SUMMARY and OVERVIEW 28/08/2025

A A Butler, Cranford Dr, Hurst, READING 28/08/2025

(1) THERE IS NO RIVER – OFF SITE NATURAL DRAINAGE NORTH AND EAST IS NOT AN OPTION:

Figure 2-3 Location Plan Showing Statutory Main Rivers, Subject Catchment Area, Model Inflow Location and Site Boundary

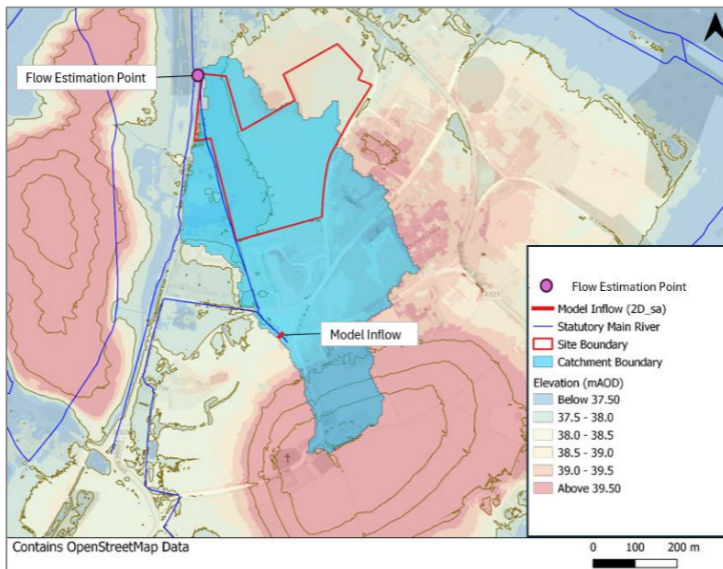
This core data dilemma is graphically indicated on the Appellant's Figure 2-3 showing the man-made drainage-obstructing Hurst Landfill hills immediately west of the site, now superimposed over virtual reality EA Main Rivers that no longer exist - the two features cannot exist together.

Loddon” now to accept site surface water drainage, and no discharge possible at the key hydraulic modelling boundary condition “*Flow Estimation Point*” – all the Appellant's submitted modelling becomes meaningless. The figure also graphically highlights serious problems with GOV.UK/EA/OS core data:

- For Hurst, OS Maps are particularly inaccurate with key relevant features, including landfill hills, stored water and active waterways – either not shown or not annotated.
- The online EA Main River database – largely matching pre-landfill 1967 OS Mapping - requires very urgent update to avoid wrong decisions being made in ignorance - based on seriously misleading information provided by normally respected official sources.

For now, surface water drainage from this site will continue its tortuous route first south anti-clockwise around Church Hill, then east and north – exacerbating reported S-19 flooding at Keyers Bridge and Hogmoor - before draining back northwest via the Green Man (Hogmoor) and Stowe (Broadwater) ditches to the Twyford Brook (ditches visible top right Figure 2-3).

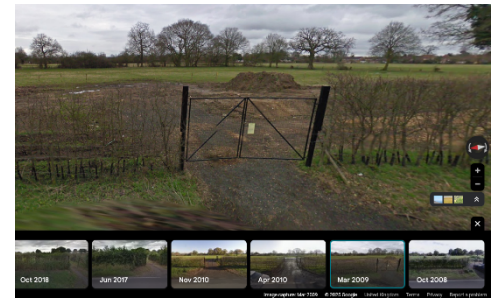
(1.3) Hurst Landfill segregation ditch west of site still appears to have been mistaken for EA Main River – viz: latest FRA Rev06 para 2.2: “*An unnamed watercourse is location to the west of Lodge Road and appears to flow in a northerly direction*”. The normally fairly stagnant segregation ditch is not EA Main River and is definitely not suitable for the Appellant's site drainage discharge.

The leachate-contamination segregation ditch pictured in the Appellant's “Walkover survey site photos” (right) is located on Summerleaze's private land, part of the waste landfill, and drains south to Lea Farm leachate treatment plant and gas flare compound. The same Rev06 FRA Site Location Plan Figure 1-1, shows no rivers or ditches west of Lodge Road but does show the Appellant's on-site truncated and blocked section of Hatchgate Ditch (now swale) which no longer flows anywhere.

Photograph 10: Manhole in a northeastern direction from site

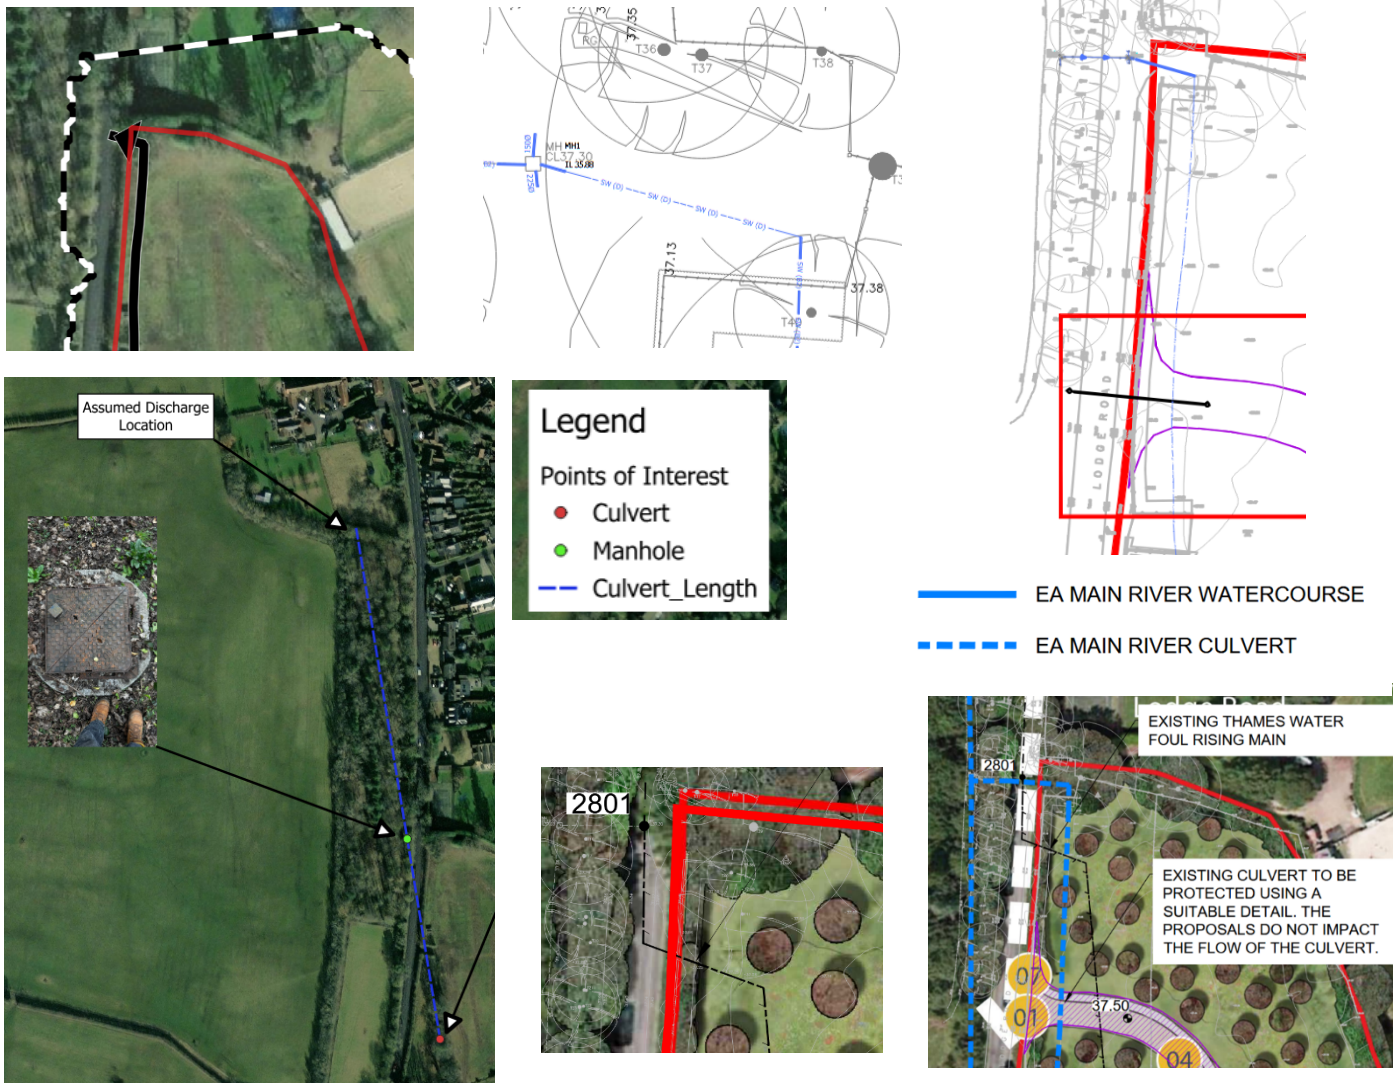
This history is relevant because it indicates a general position and layout of on-site culverts and open ditch in 1967 under the joint access drive with “The Paddocks” (on the right of IMG_0805 screenshot left). Other photos show Hatchgate Ditch immediately roadside west of Lodge Road is now defunct and completely filled-in, the present Landfill segregation ditch now running roughly 40m west of what was the roadside Hatchgate Ditch. Below left IMG_0803, a similar view east towards Thames Water Manhole 2801 from “Howard’s Way” footpath including the “vented” Summerlease landfill bio-solids

leachate pipe discharge manhole - giving access to the (pink) discharge isolation valve. The appellant’s own photos, immediately west of the site by Lodge Road, including in the view south in wrongly labelled Photograph 10, show the absence of any west roadside Hatchgate Ditch. The much-photographed Summerlease discharge Manhole in IMG_0801 is nothing to do with site drainage.

Figure 2-1: 1D/2D Hydraulic Model Extent and Features

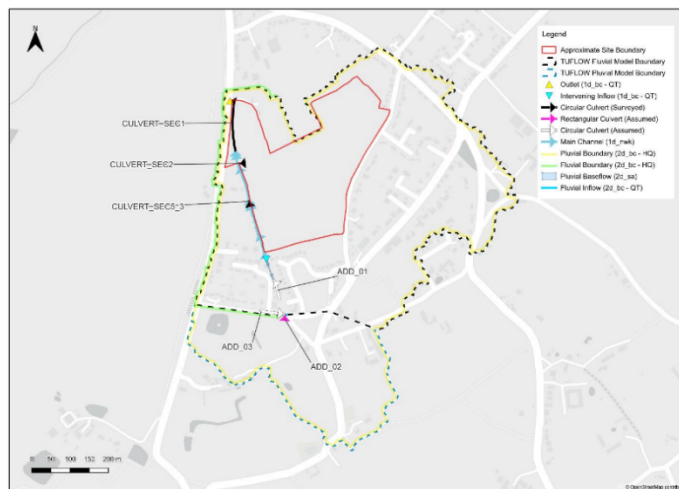
(5) The oddly suppressed, very selective hydraulic modelling boundary chosen, with a major error in a key boundary condition, will sadly only ever produce worthless results; for Hurst a much wider logical relevant area of the containment basin must be considered to produce realistic results.

The west boundary of the model stops just short of the Summerleaze landfill segregation ditch, stops just short of the surcharging Hogmoor Lane Manhole, only includes a little bit of Church Hill, and no inflow from the impervious landfill hills, etc.

Figure 2-2: Hydraulic Model Topography Changes

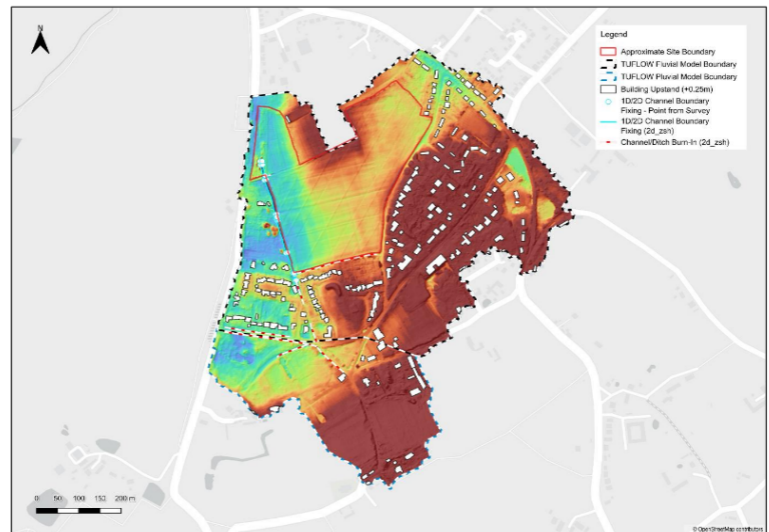
(5.3) For comparison hydraulic modelling would one not expect to see a “base case”, with the site “as is”, then an “as-built” case for comparison – complete with raised dwellings and the site built-up as implied with 50,000+ cubic metres of soil, rubble, paving and concrete? If this aspect is covered by 5ha of the site being modelled by a catch-all “*urban*” factor, we need to know how this corresponds to what is actually to be built? Appellant’s LiDAR terrain “*Figure 2-2*” has a title “*Hydraulic Model Topography Changes*” but shows no changes – just the undeveloped as it is now? The purpose of the model appears to quantify “*flood risk to land proposed for residential development*” - so just a “base case” rather than the more relevant **flood risk to neighbours from the “as-built” developed raised site** – which is what Hurst residents really need to know. Where are the comparable “LiDAR-type” terrain details of the dwellings and surrounding raised developed site for meaningful modelling comparison?

(5.3.1) Item 22 of the “Not agreed Conditions 19/08/2025” states “*proposed finished ground levels and finished floor levels across the site to be set at a minimum level of 38.13mAOD*” – note the word minimum above the present near 37.5mAOD seasonally waterlogged site. The Appellant’s “access-only” indicative drawings show the surface of the on-site “retention pond” at 38.0m AOD – the new pond raised more than 0.5m above the level of existing seasonal ponding on-site and relative to neighbours. A common-sense statement (or perhaps responsibility shifting disclaimer?) is made at the end of FRA para. 7.4.3 affirming Archimedes’ principle and most Hurst residents’ understanding of what will happen: “*7.4.3 Exception Test – Fluvial Flooding: Therefore, provided there is no land raising within design flood envelope without suitable compensation elsewhere, the proposed development would not increase the flood risk elsewhere by virtue of the reduction in floodplain storage or the obstruction of flood flows.*” The unanswered question is – “By how much is the near 37.5mAOD 10.68ha site to be raised – and to meet the condition, where is the 50,000+ cubic metres of suitable flood compensation elsewhere provided?” The indicative 38.0mAOD high retention pond at less than 2000 cubic metres would have negligible effect - being less than 4% of the required volume needed of flood compensation ditches, swales and ponds below 37.5mAOD – which in winter and spring, in Hurst, will be full of water anyway.

Figure 1-2: Extract of the Flood Map for Planning

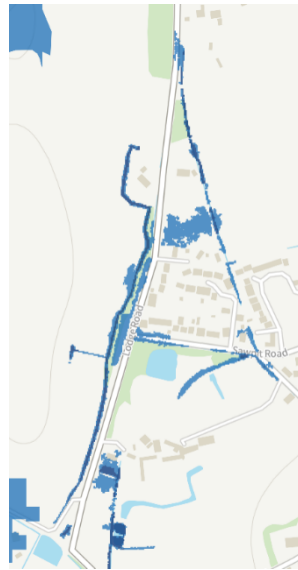
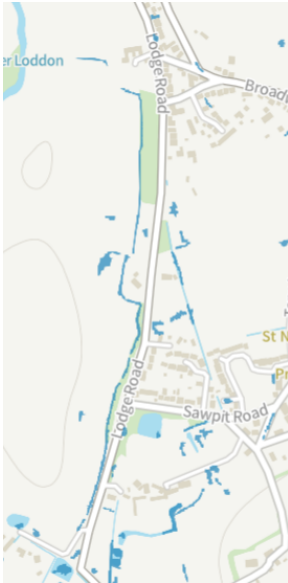
Comparison of online Flood Zones (right), one without the site marked, and one with the site outlined in red – both show the ditch subject to Flood Zone 3 stopping immediately north of its detour around Old Lodge at the Summerleaze site access.

The flood map for surface water flooding (above left) on the other hand indicates the ditch continuing to run northwards beyond the Summerleaze access to its start near Whistley Farm. The reasons for these differences may be that two different LiDAR databases are being used – perhaps one data set scanned when trees were full leaf – the other in winter. But whatever the reasons for the differences, this ditch -not shown on OS and EA data – very much exists and must be included in any modelling.
